CITY OF SARATOGA SPRINGS
DESIGN REVIEW COMMISSION

Design Review Commission Meeting – Wednesday, November 16, 2016

A. 2016.075 Obstarczyk Garage Demolition

RE: 147 Spring Street – Demolition of Accessory Structure and New Construction

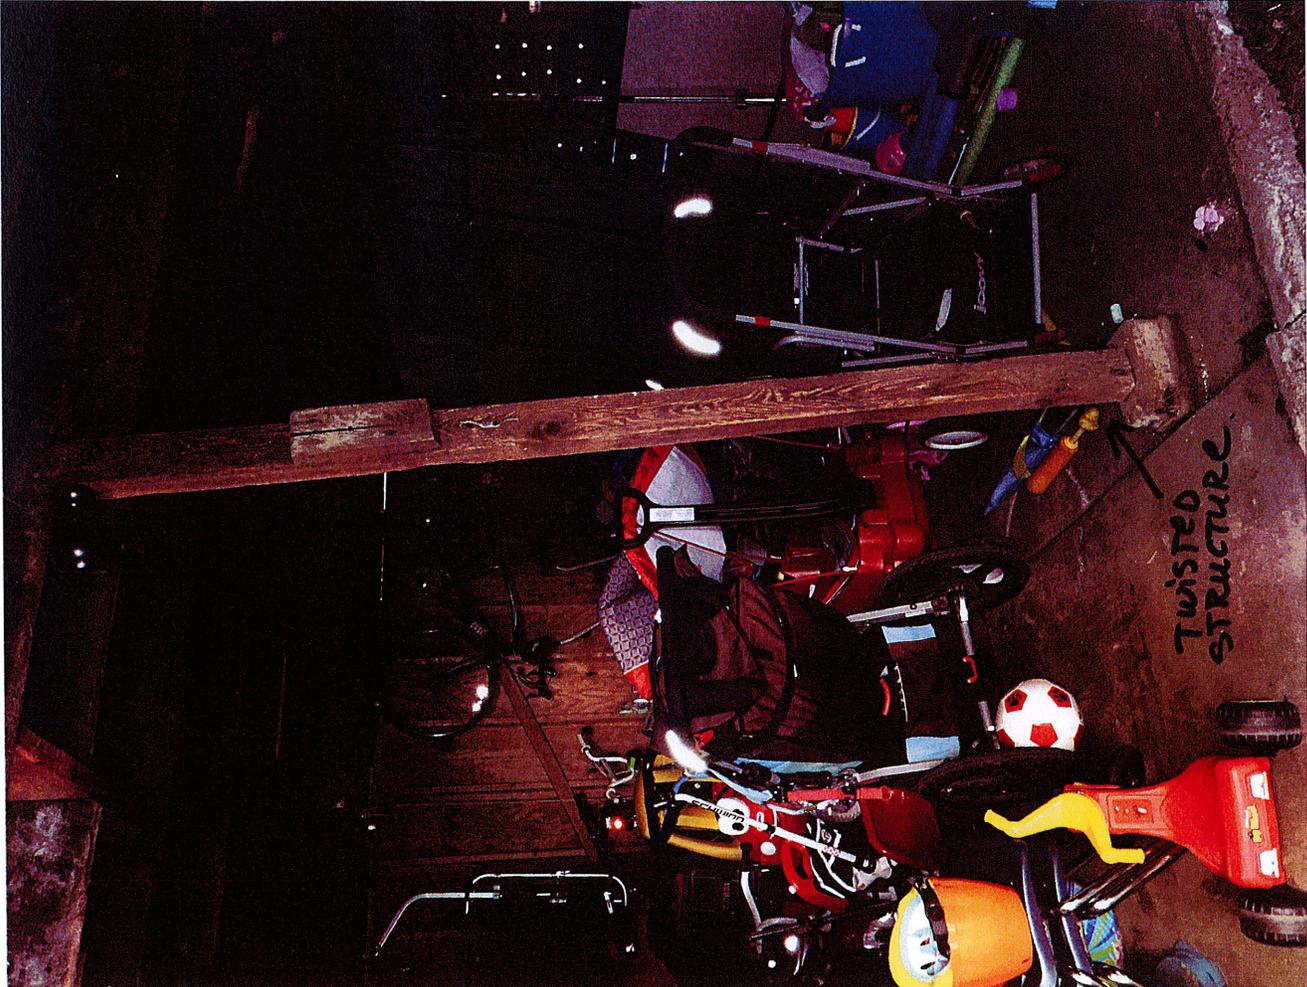
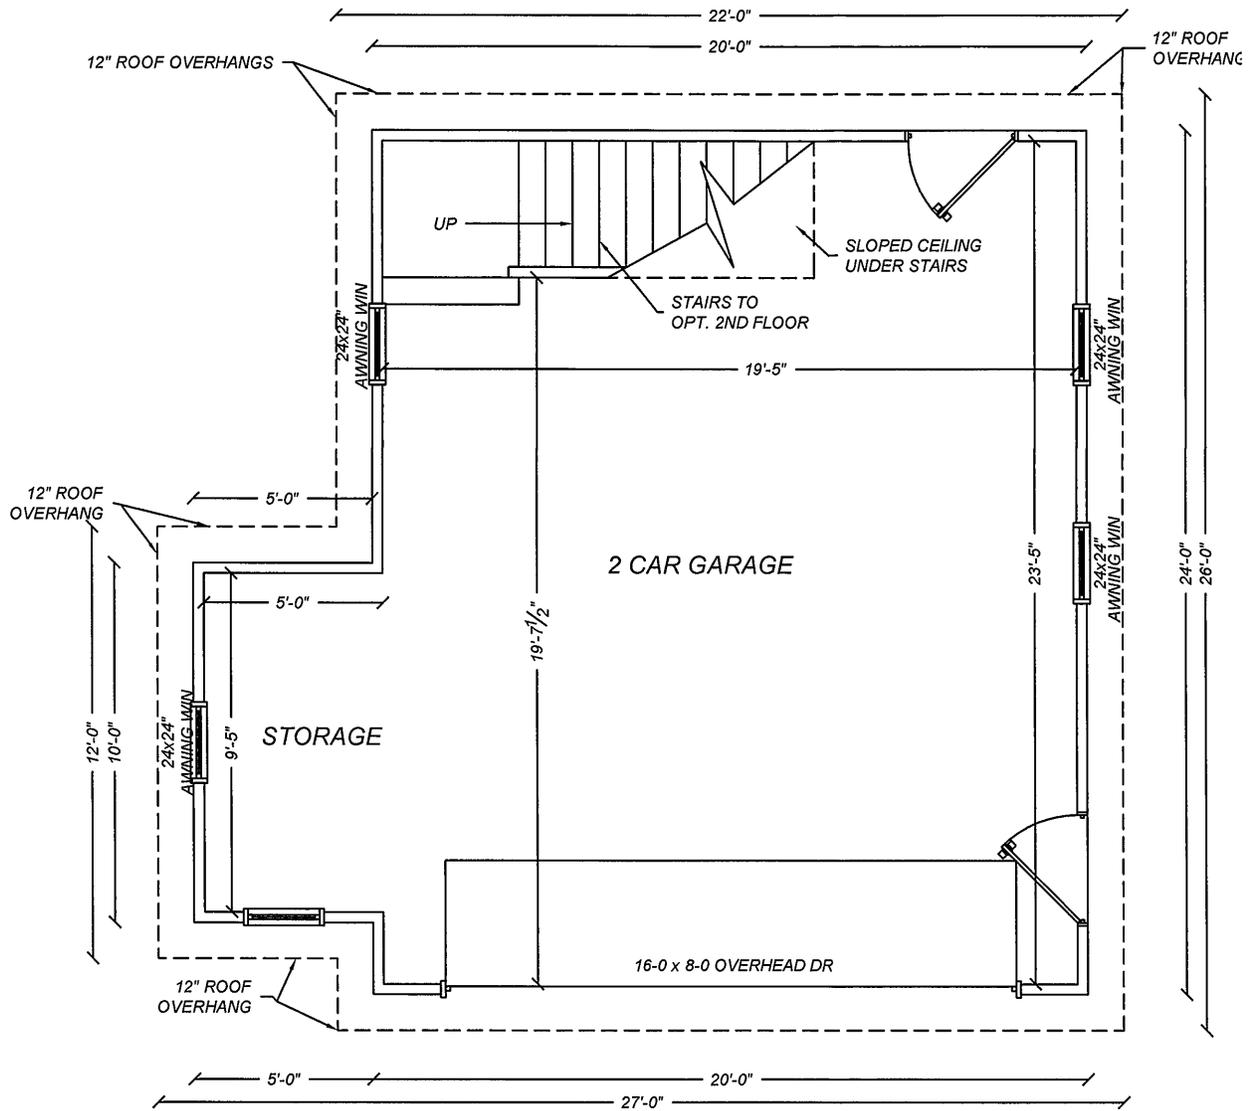
← LACK OF SILL PLATE AT WALL

TWISTED STRUCTURE

CORNER OF STRUCTURE
of STRUCTURE
skewed

THIS PORTION
of wall
framed straight

THIS PORTION
of wall skewed
TO MATCH TWISTED
STRUCTURE
